Proposal for amendments to ECE/TRANS/WP.29/GRE/2019/03

I. Proposal

Headlamp mounting height (m)

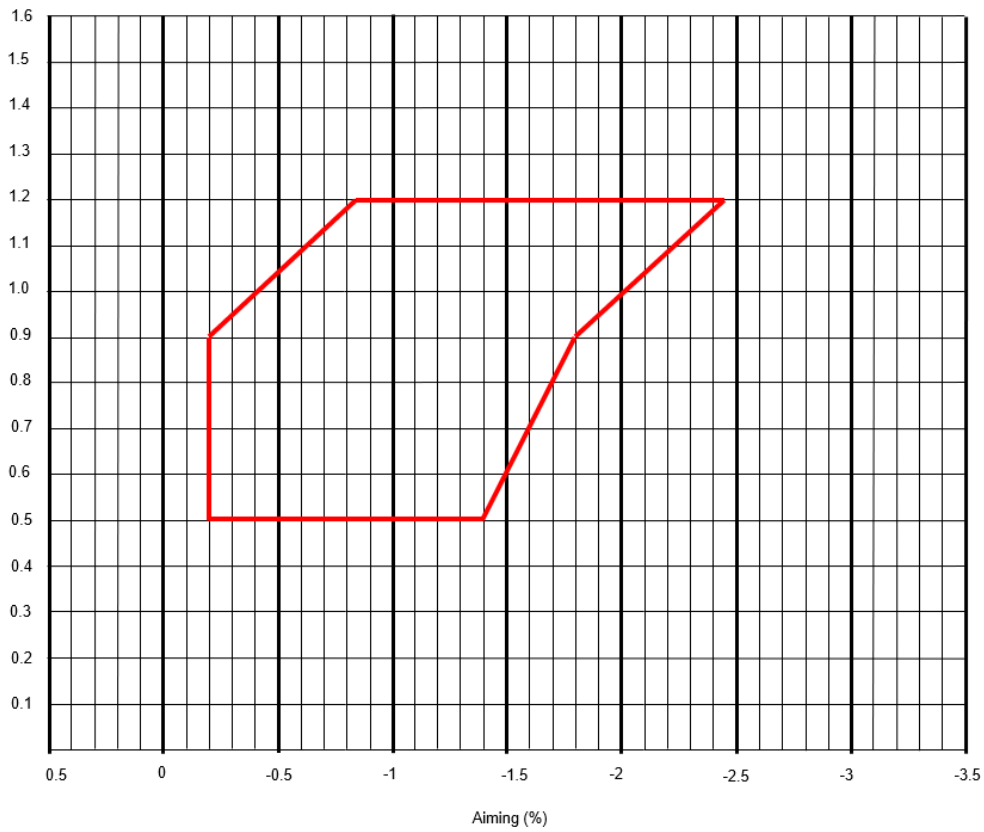
Paragraph 6.2.6.1.2., replace the blue figure by the figure in red (as agreed during the GRE 81st session):

1. This is the agreed results to amend the blue diagram under paragraph 6.2.6.1.2. It shall be the basis for updating document ECE/TRANS/WP.29/GRE/2019/03
